SECTION 009113 – ADDENDUM ONE

- A. Project Name: Alliance Fire Station
- B. Owner: Madison County
- C. Architect: Dale Partners Architects, PA
- D. Architect Project Number: 22019
- E. Date of Addendum One: 26 October 2022

22019 Alliance Fire Station / Pre-Bid Meeting

E000 ELECTRICAL LEGEND

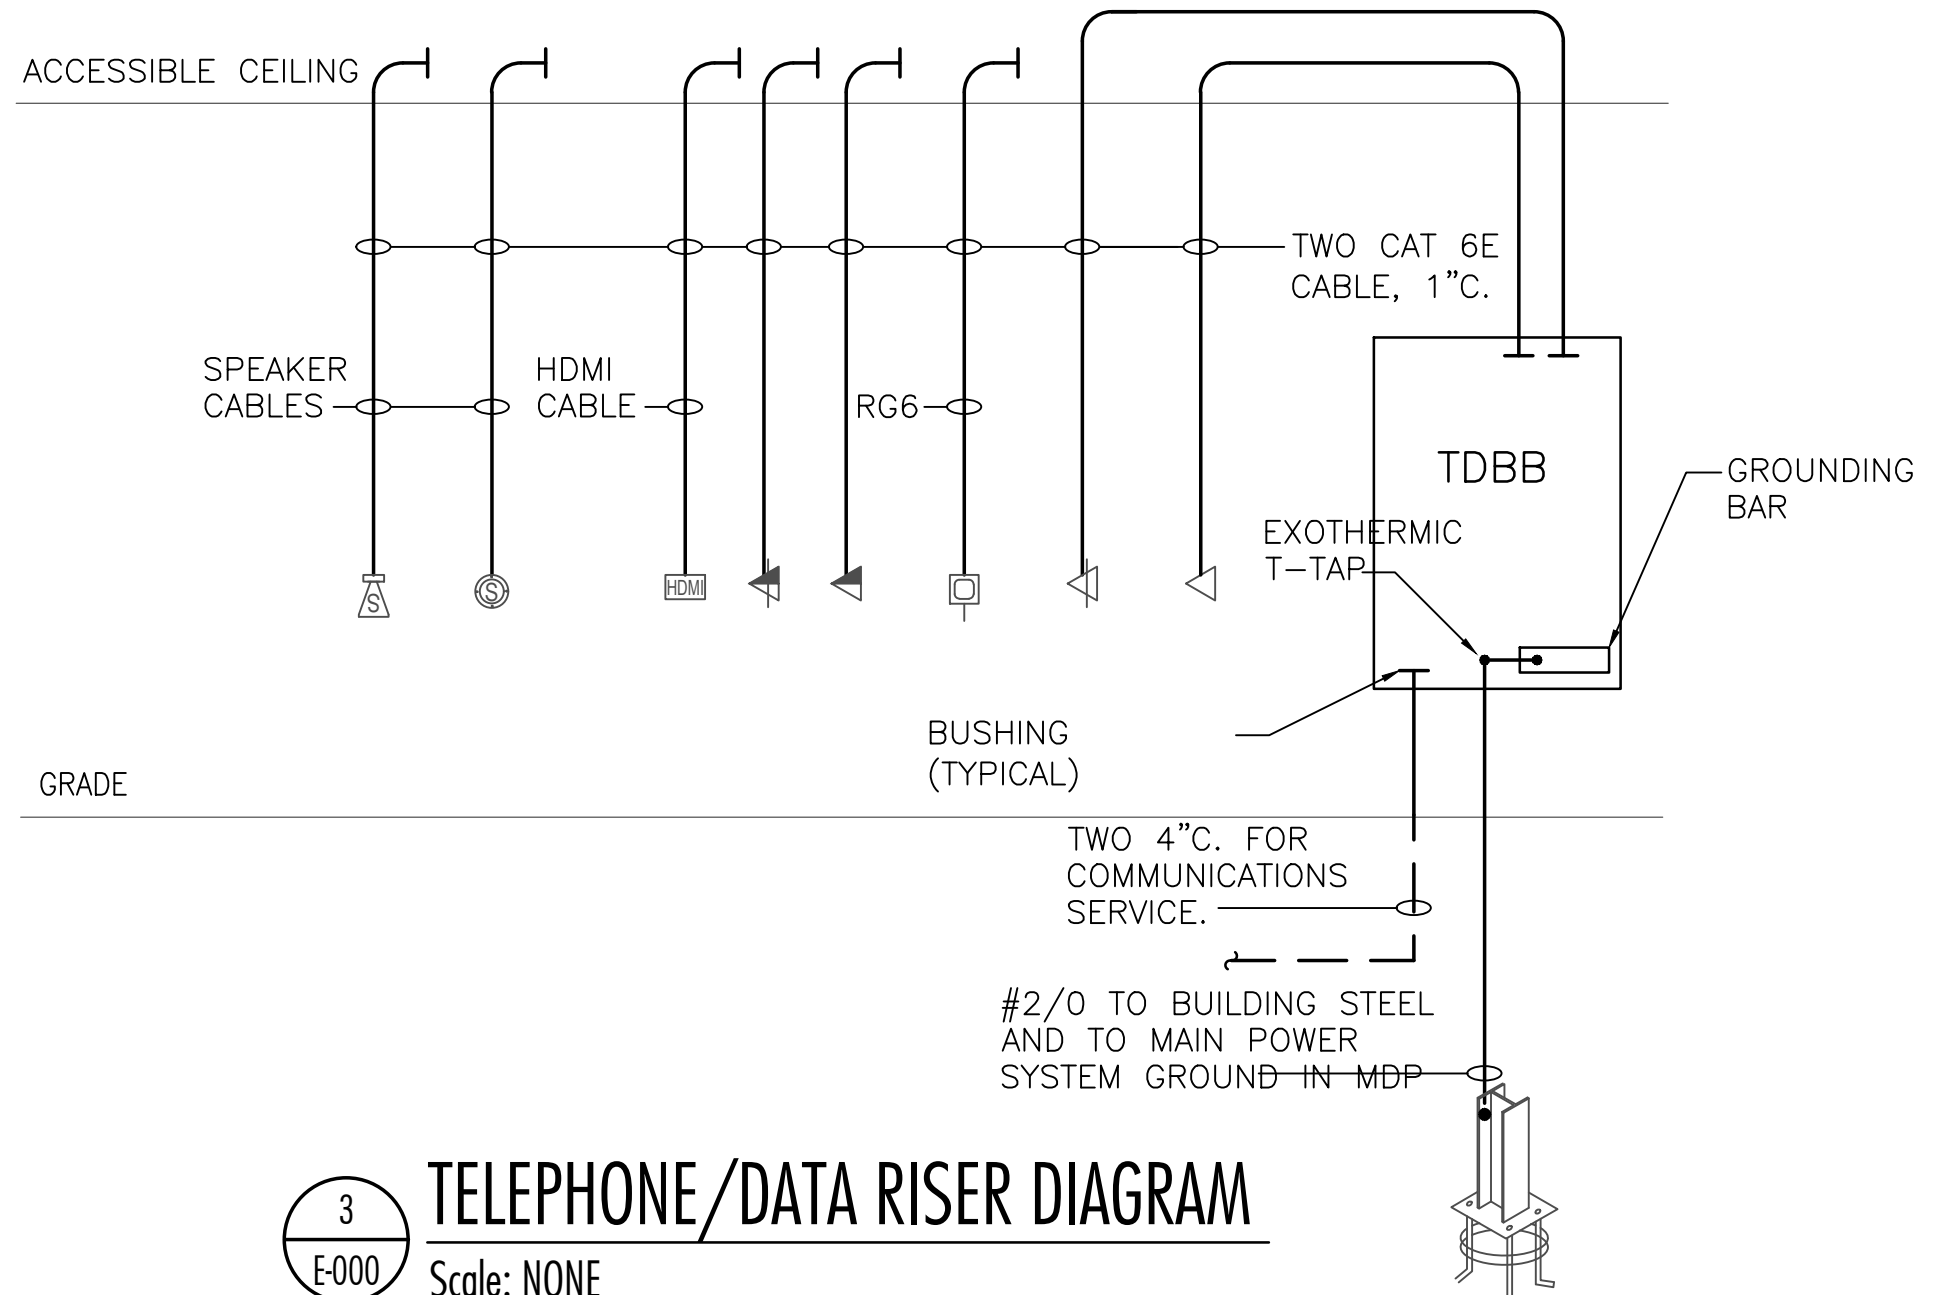
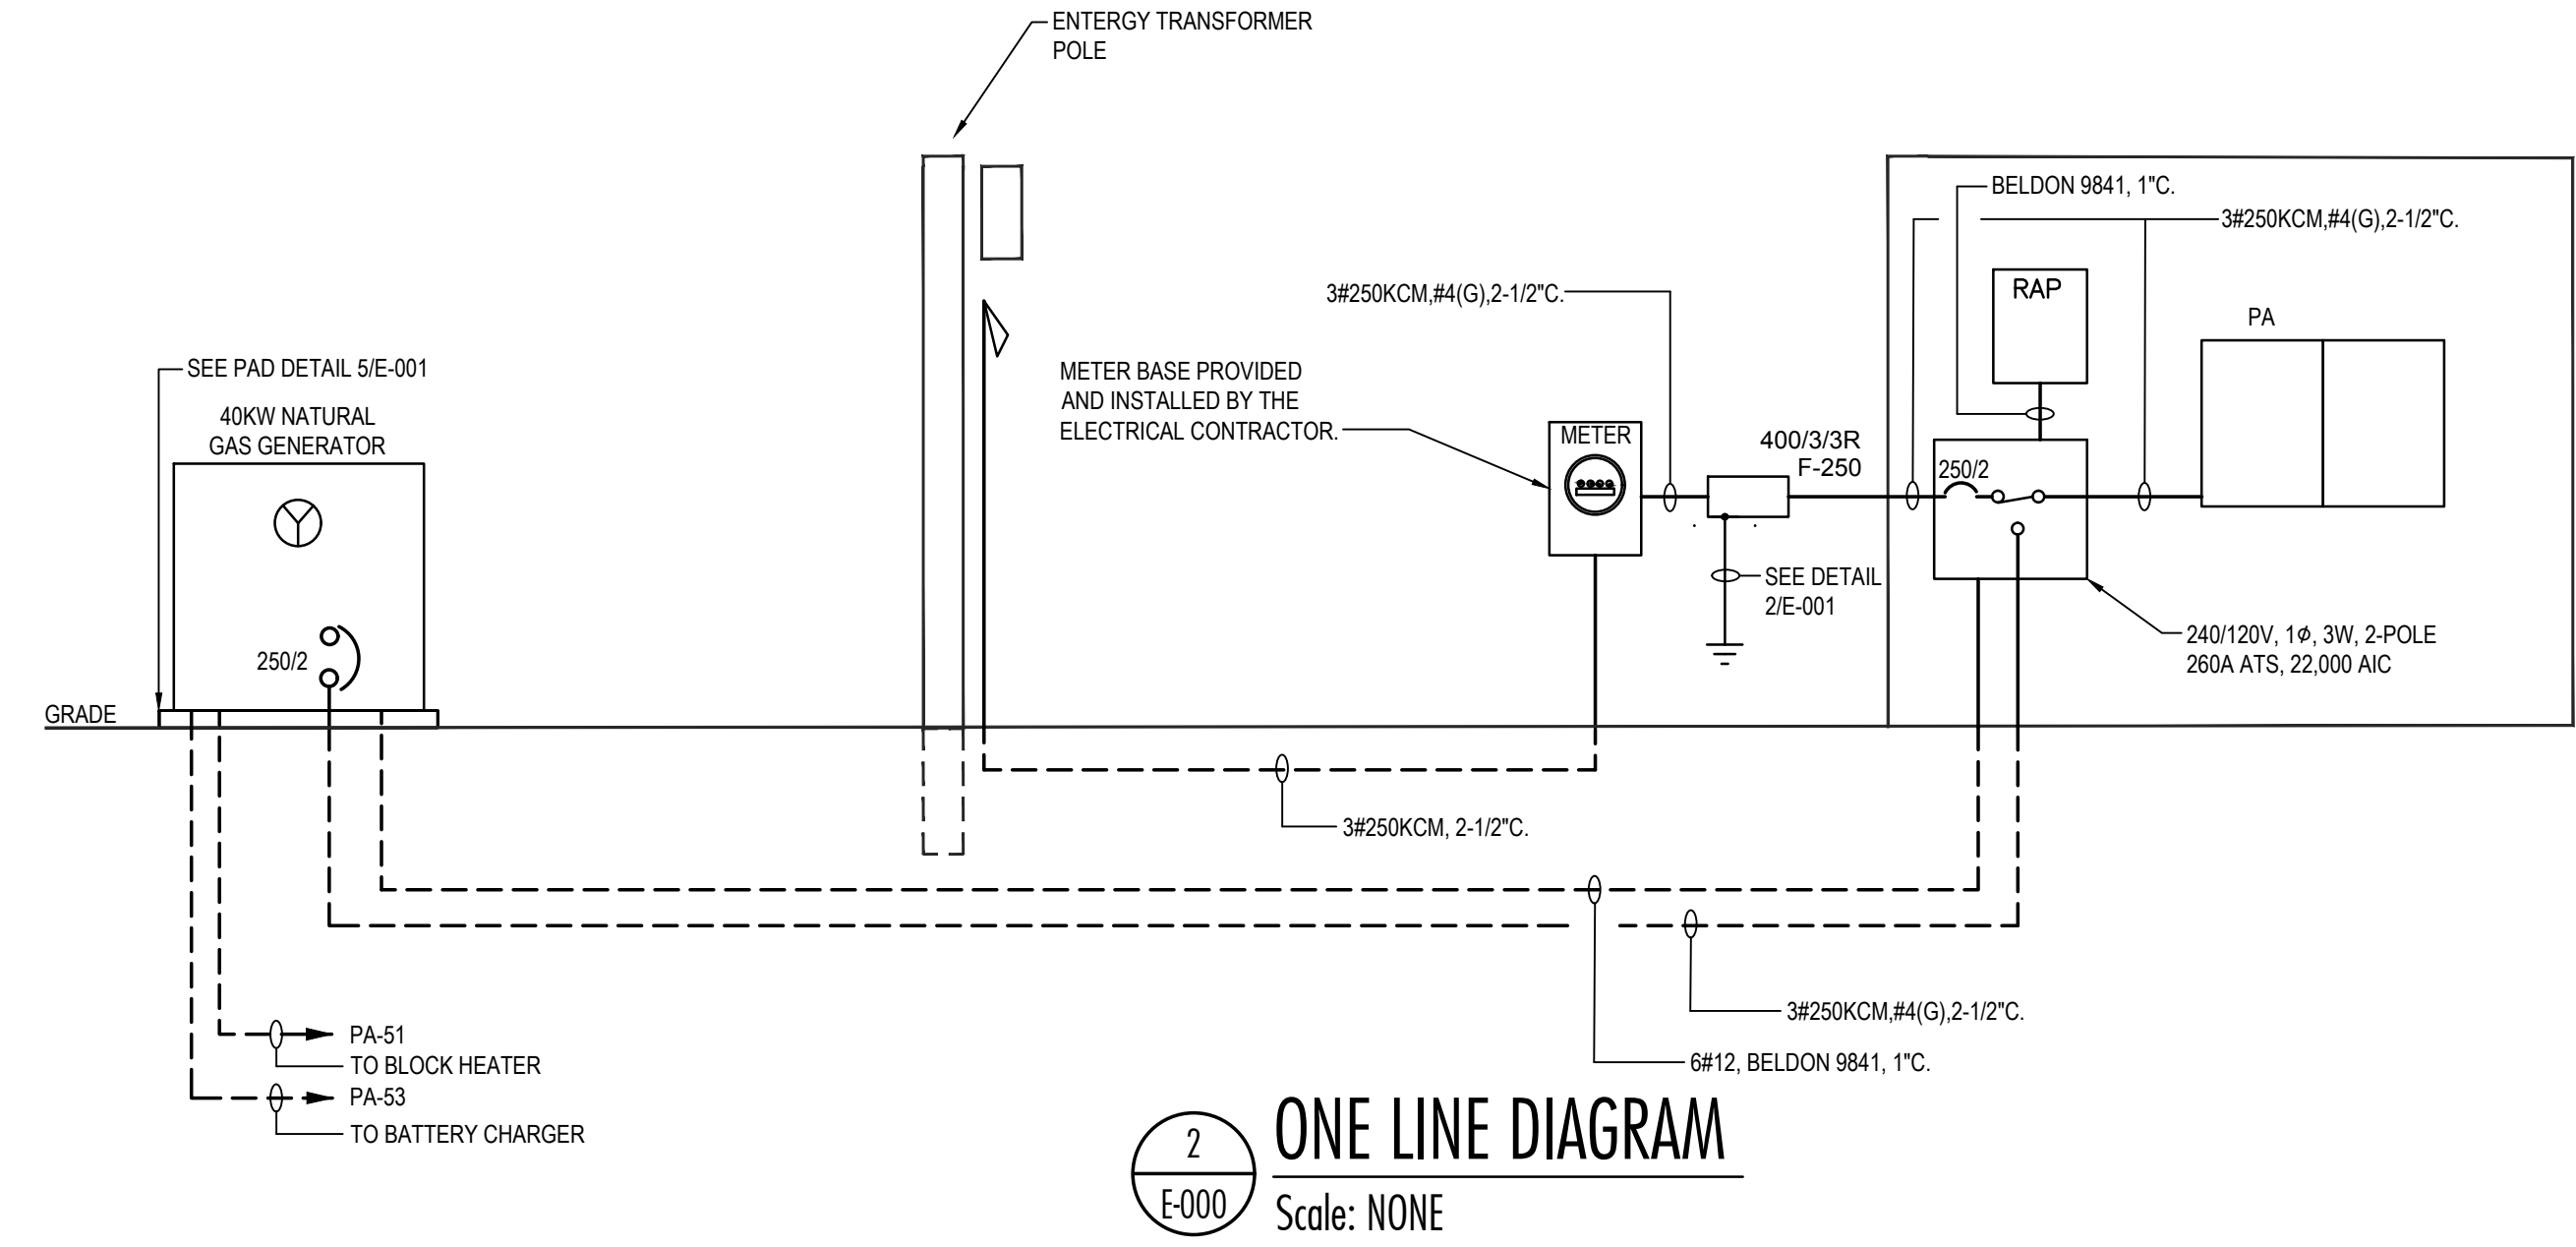
- Answer: The wording on this alternate was reversed. Please provide CMU walls instead of stud walls as the scope for this alternate.
- F. Question: There is a SA light on the plans but nothing on the fixture schedule, can we get clarification on what type of light this needs to be?

- A. Electrical Sheet E000 – ELECTRICAL LEGEND. Delete the sheet in its entirety and replace with the attached. Added flagpole fixture (SA) to the light fixture schedule and the mounting detail for that fixture. Also added the lighting contractor detail to the drawings.
- B. Electrical Sheet E300 – LIGHTING PLAN FIRST FLOOR. Delete the sheet in its entirety and replace with the attached. Added flagpole fixture (SA) to the light fixture schedule and the mounting detail for that fixture. Also added the lighting contractor detail to the drawings

E300
 LIGHTING PLAN
 FIRST FLOOR

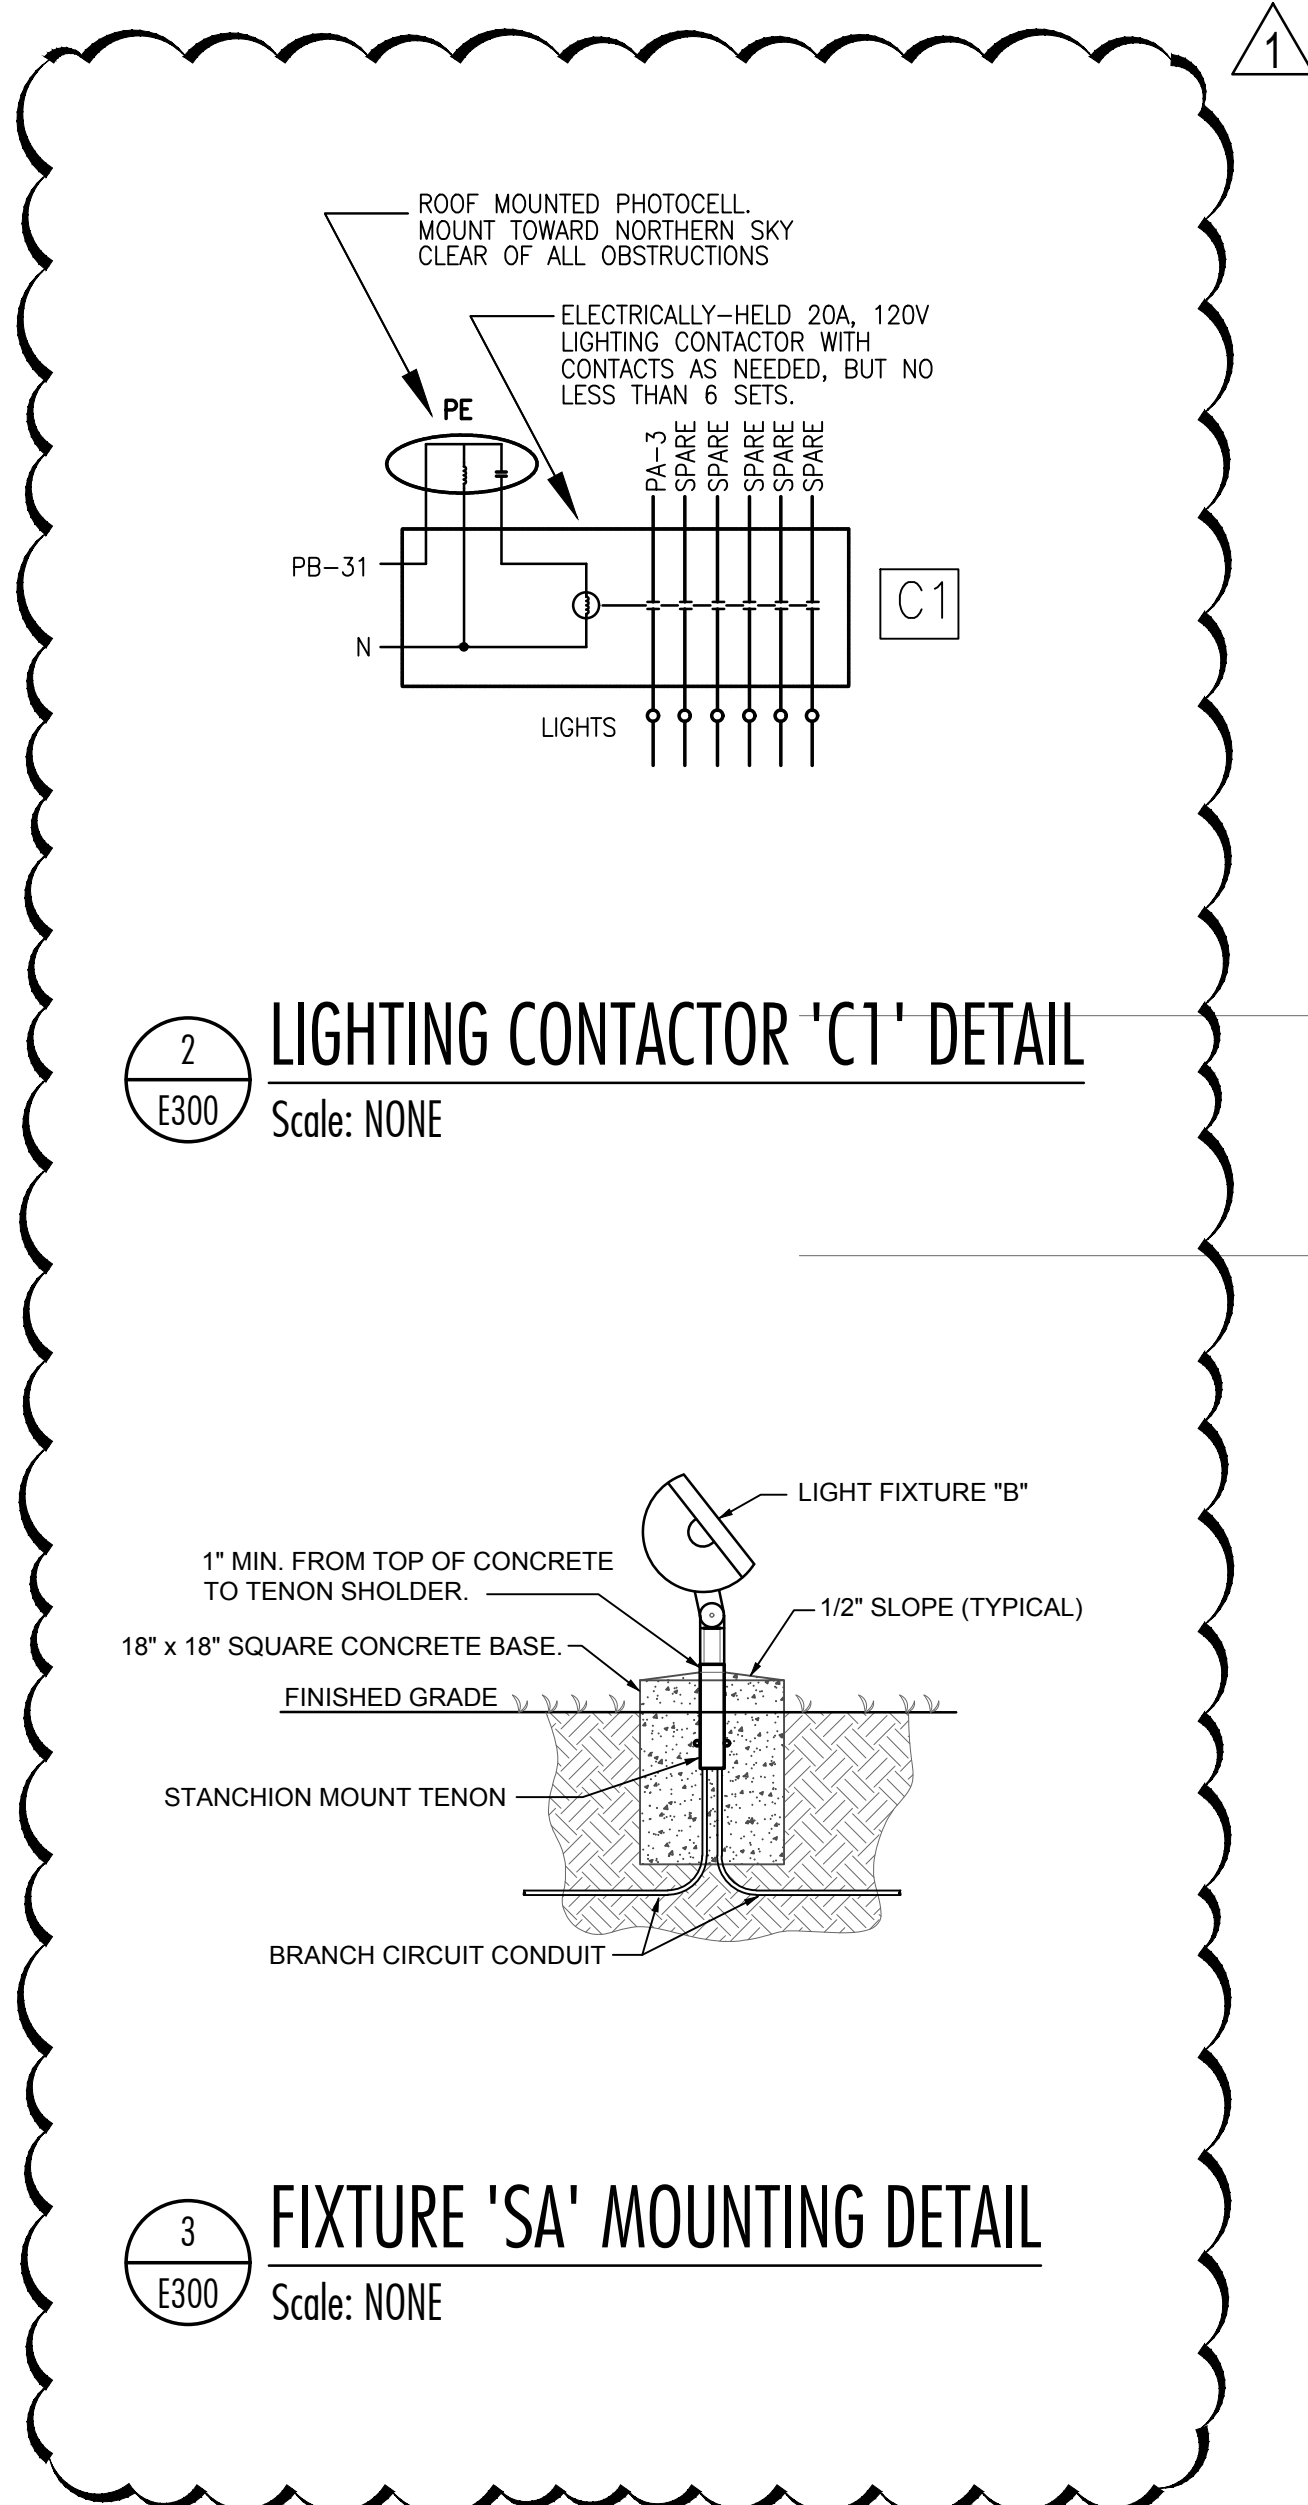
- Answer: Please see attached Electrical drawings.
- G. Question: Also, the wall pack fixtures are called to be fed through "Contractor C1" per E300. There is also a not that says see detail on this same page but there is not detail to show what is needed for this contractor.
